Date: October 27, 2022

Subject: ADDENDUM #2

Project: Transition Building
(T99) Addition

Project No: 220082

1 FIRST FLOOR PLAN
SCALE: 1/8" = 1'-0"

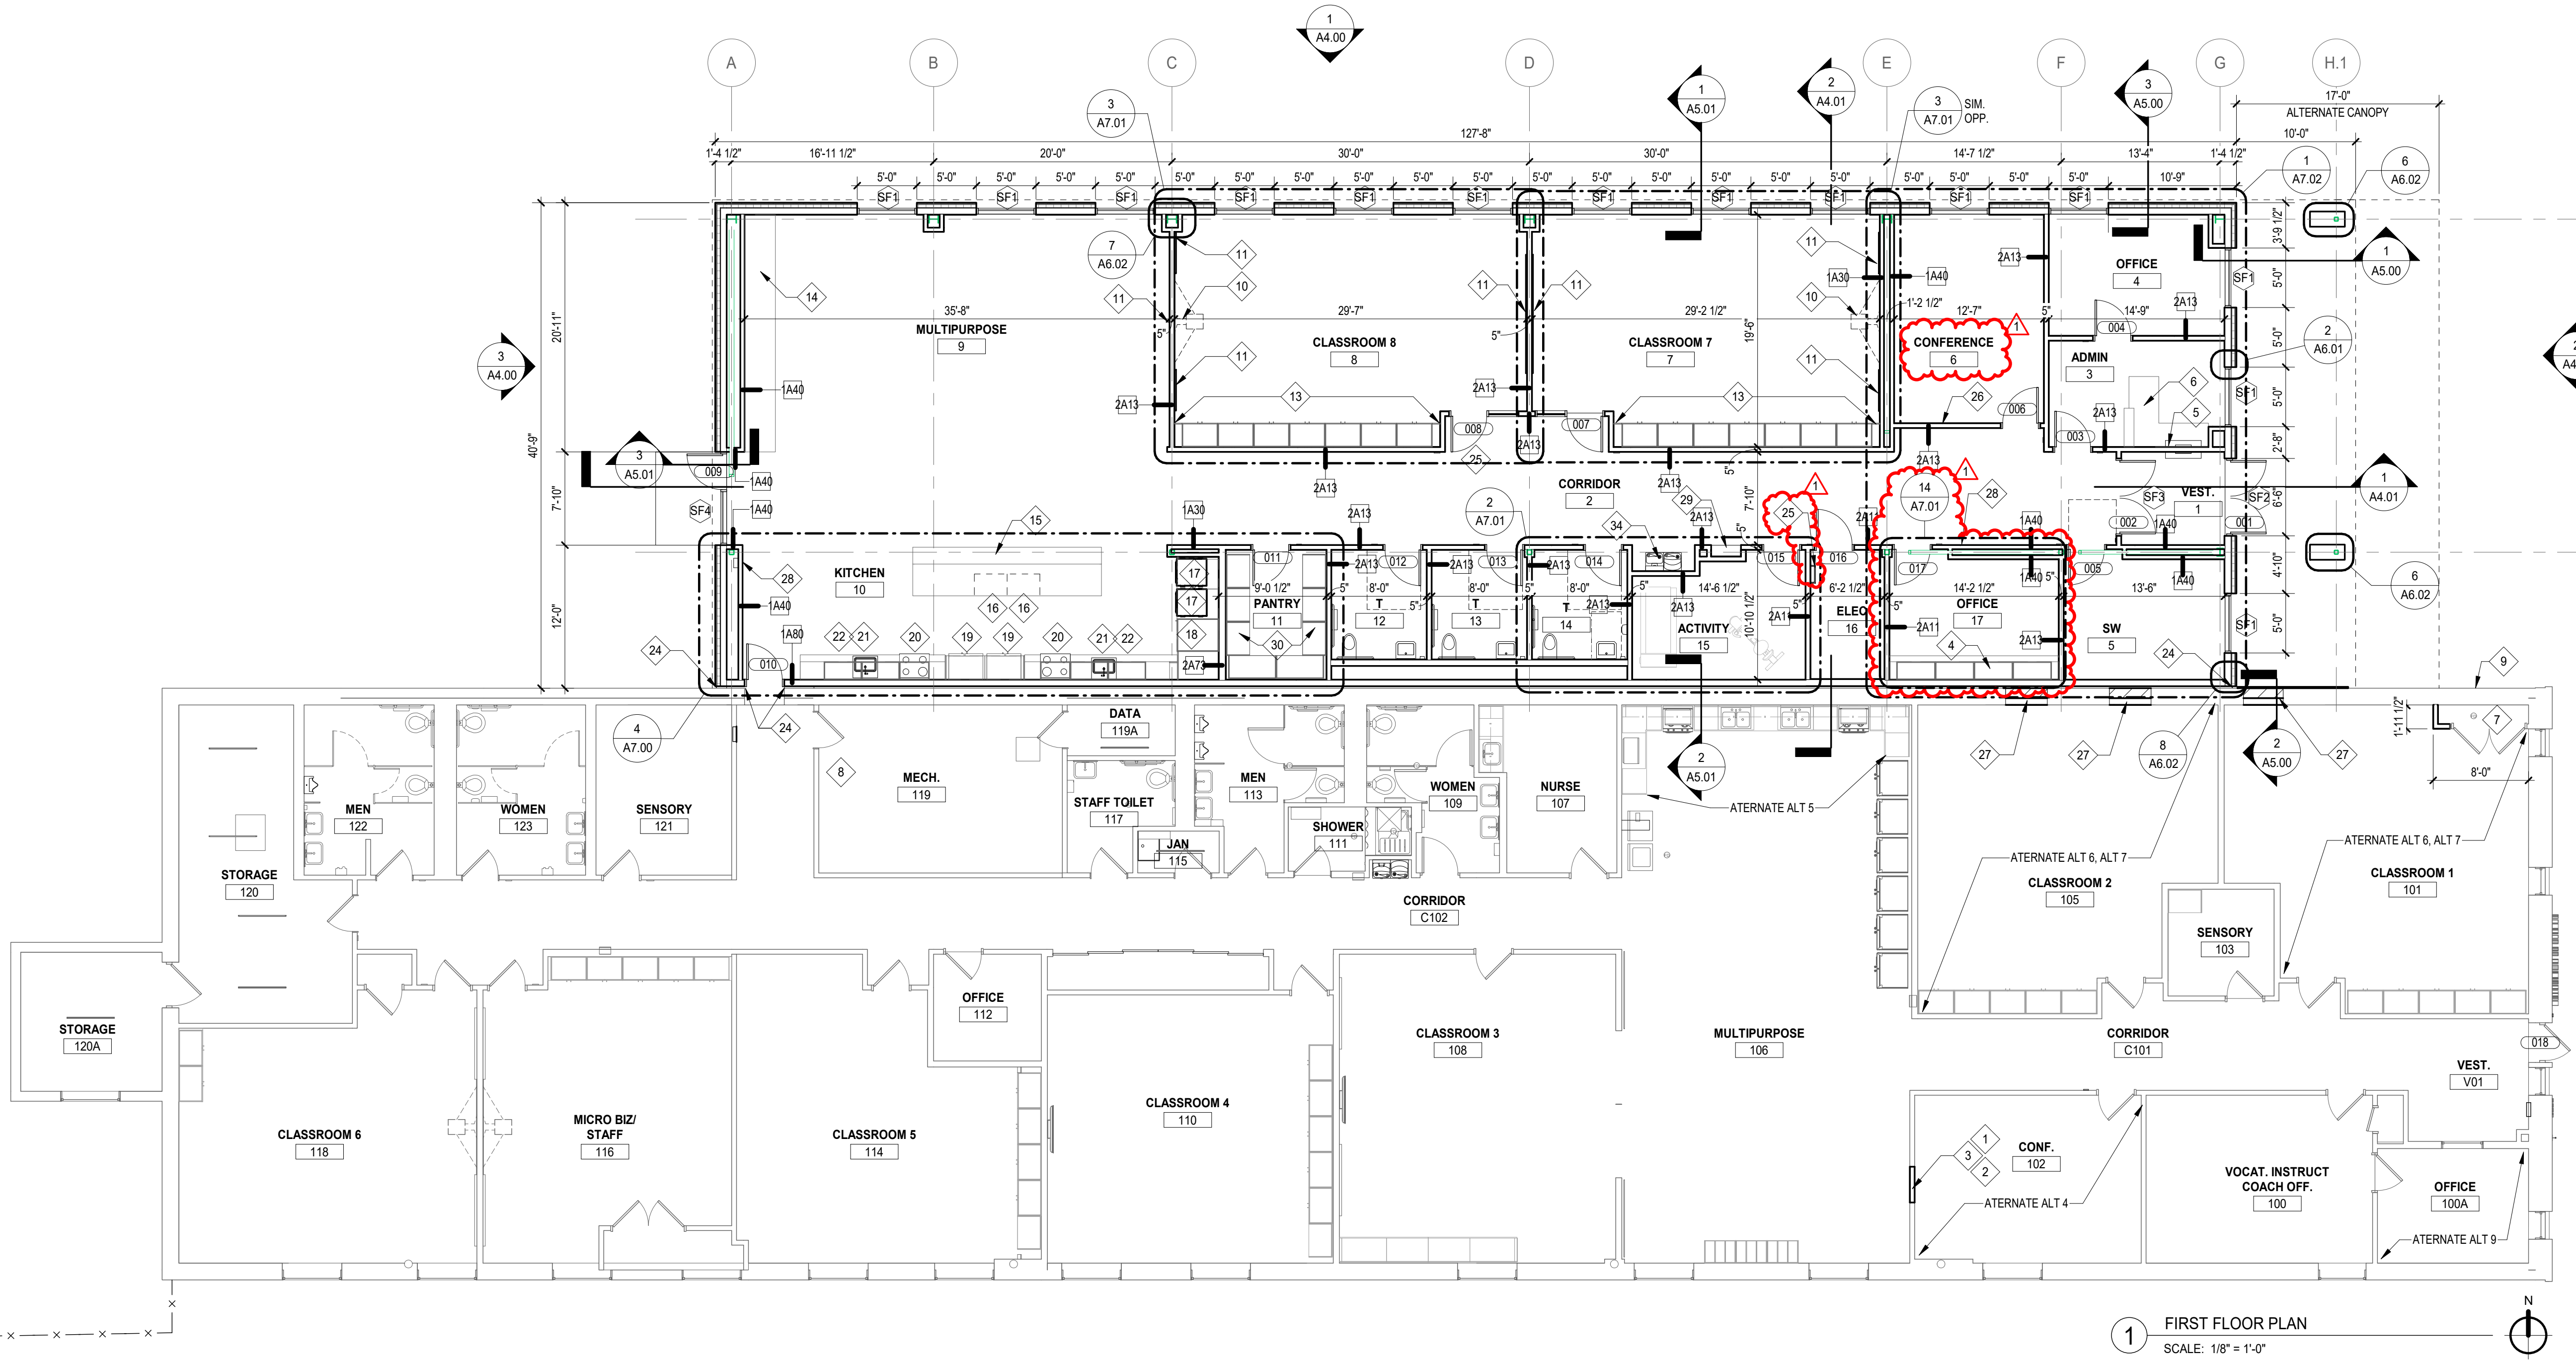
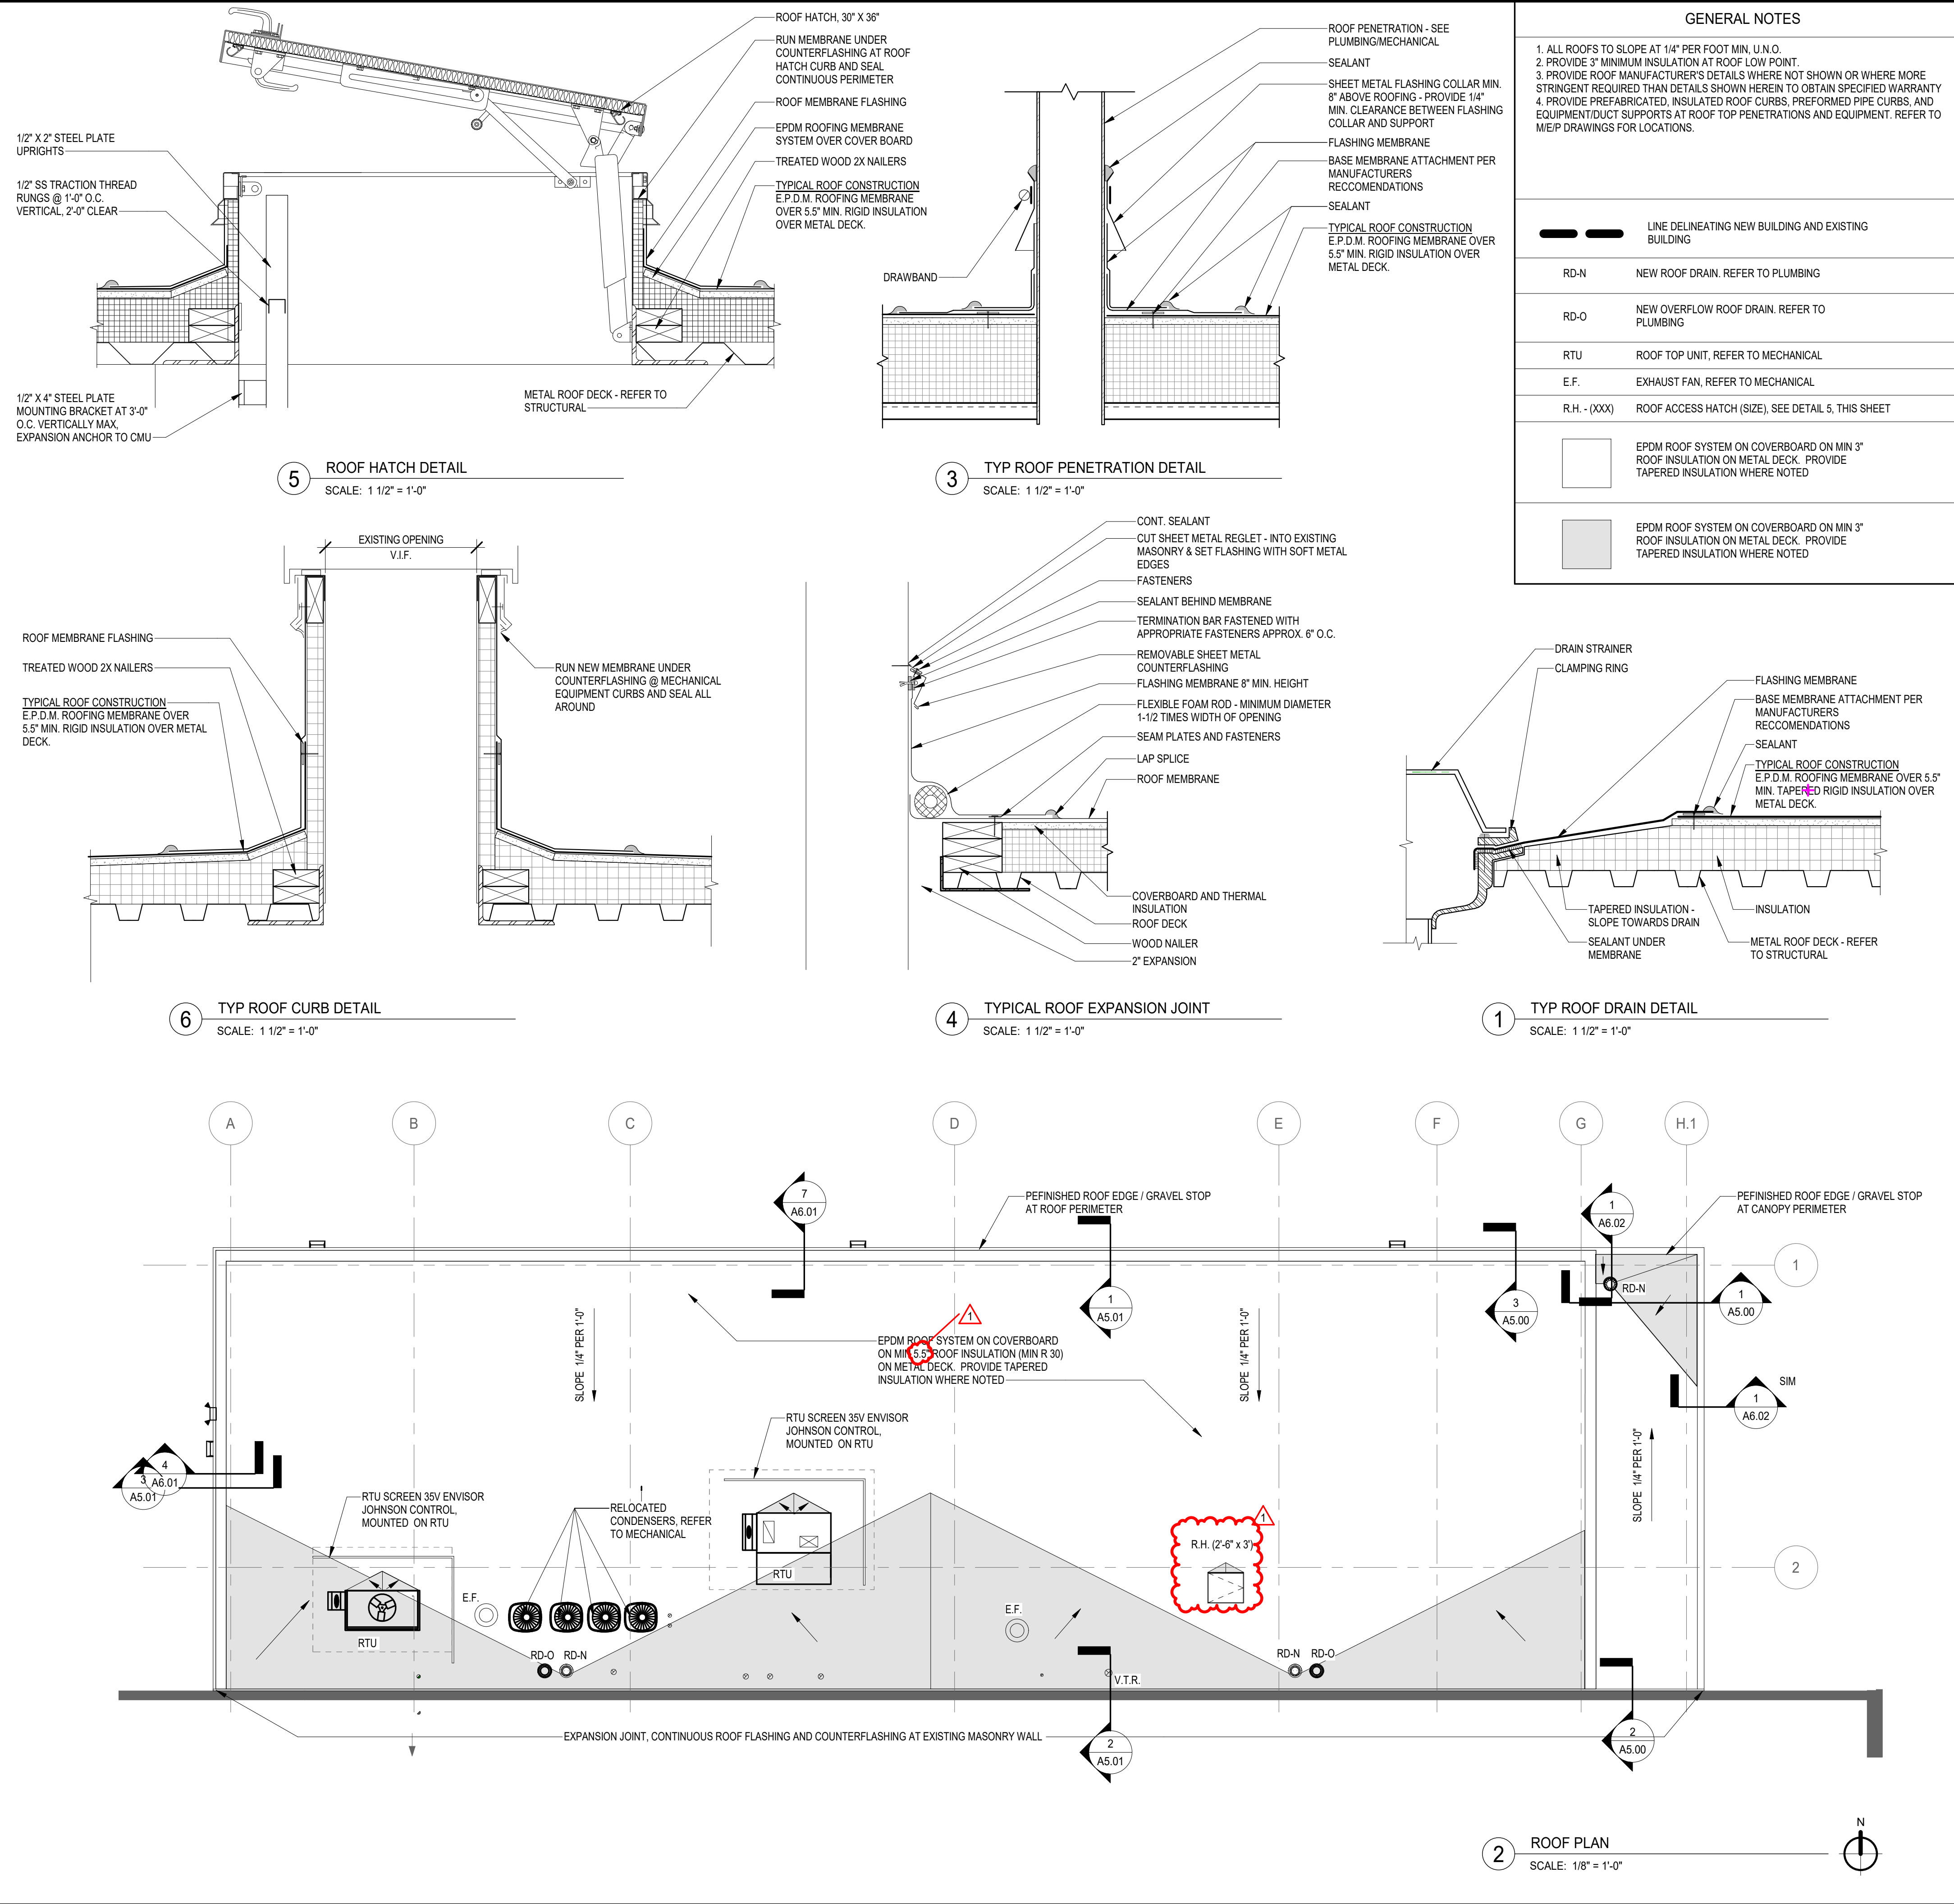
- Room 6 revised to Conference.
- Room 17 revised to Office.
- Casework moved from room 100A to 17.

- Roof Hatch moved from room 17 to 16.
 - Alternate 9 added.
 - Revised ALT 4 to call out for new light fixtures.
 - Revised Architectural Monumental Sign as Alternate 10.

ROOF PLAN

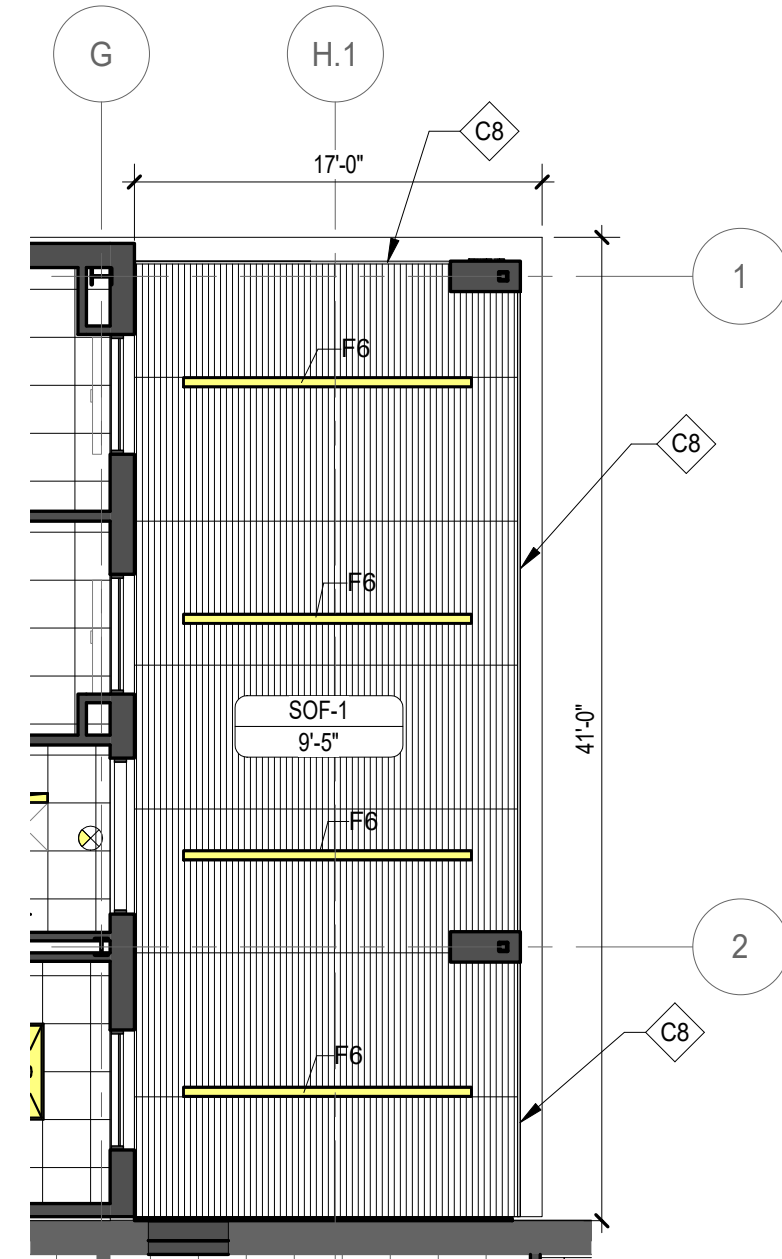
2. **SHEET A2.02** (FULL SIZE SHEET REISSUED)
 - Relocated roof hatch.
 - Revised roof note to show min. 5.5" insulation.
 3. **SHEET A3.01** (FULL SIZE SHEET REISSUED)

13 OFFICE 17 - ELEVATION - SOUTH
SCALE: 1/4" = 1'-0"

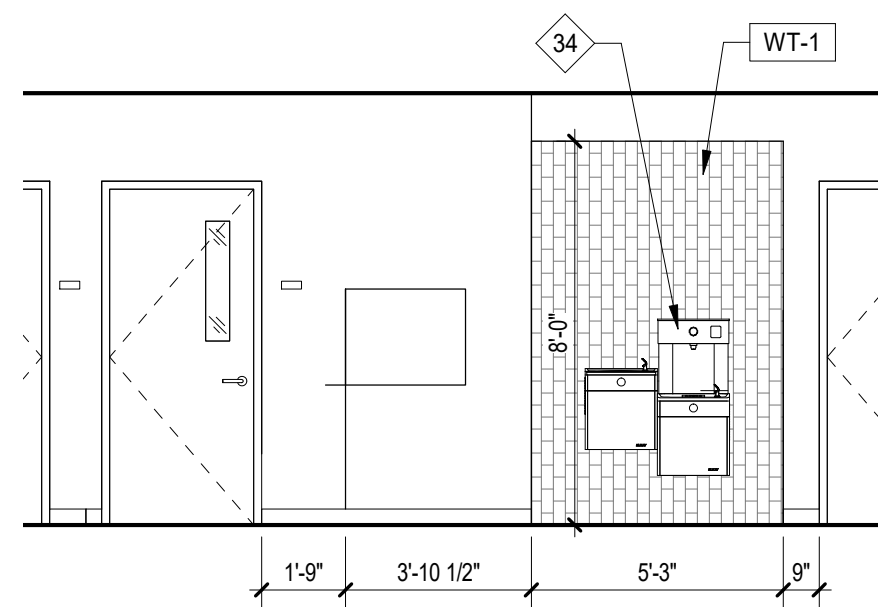
7. **SHEET A7.01** (FULL SIZE SHEET REISSUED)
 - Revised plan and elevation details 13 and 14 to show Office room no 17 in lieu of 100A.
 - Updated Toilet Room Accessory List to show model numbers.

1 COUNTER SECTION
SCALE: 1 1/2" = 1'-0"

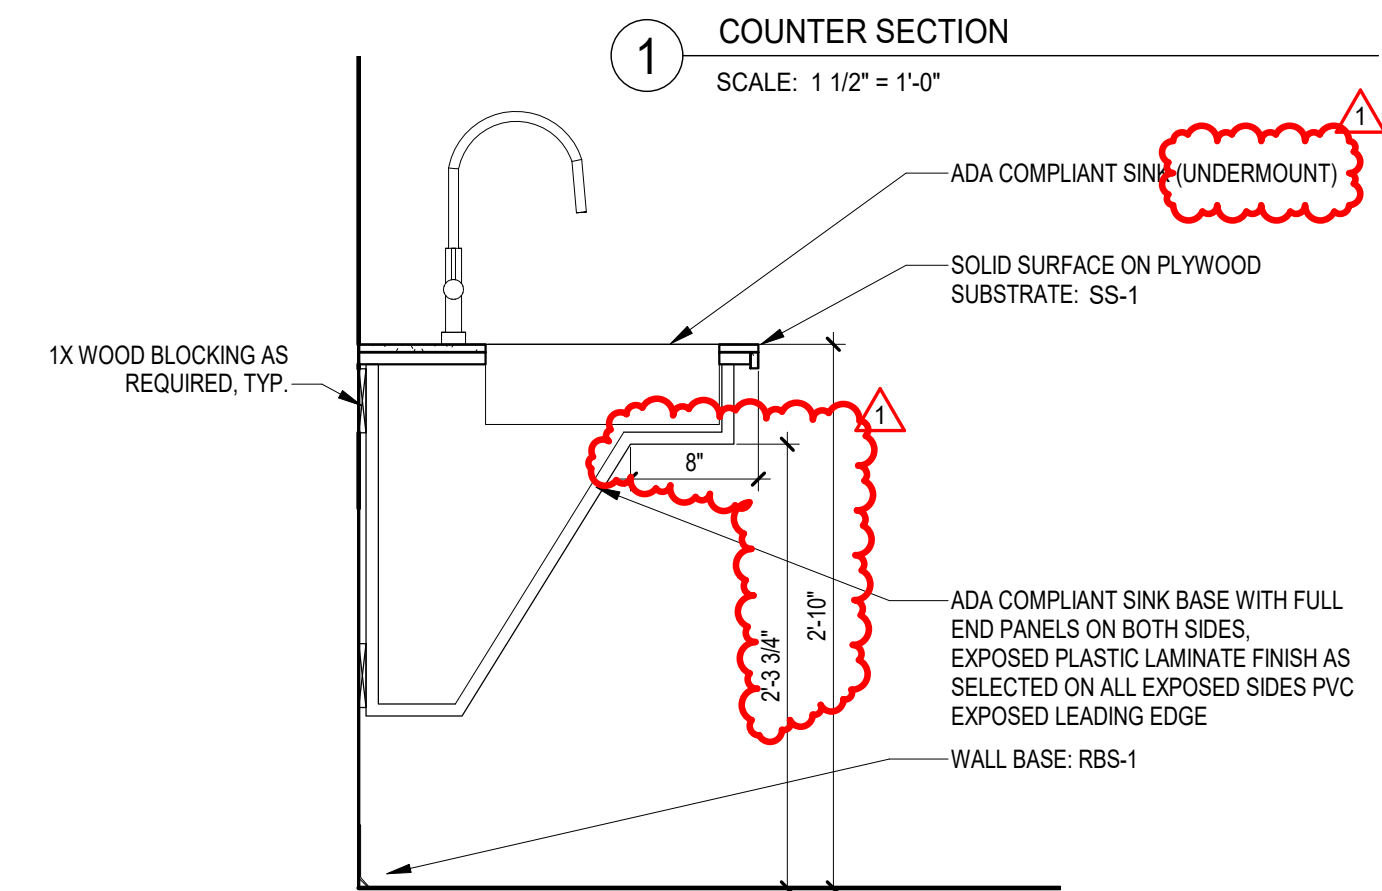
- Revised counter detail 1 to show 2" gap to the wall.
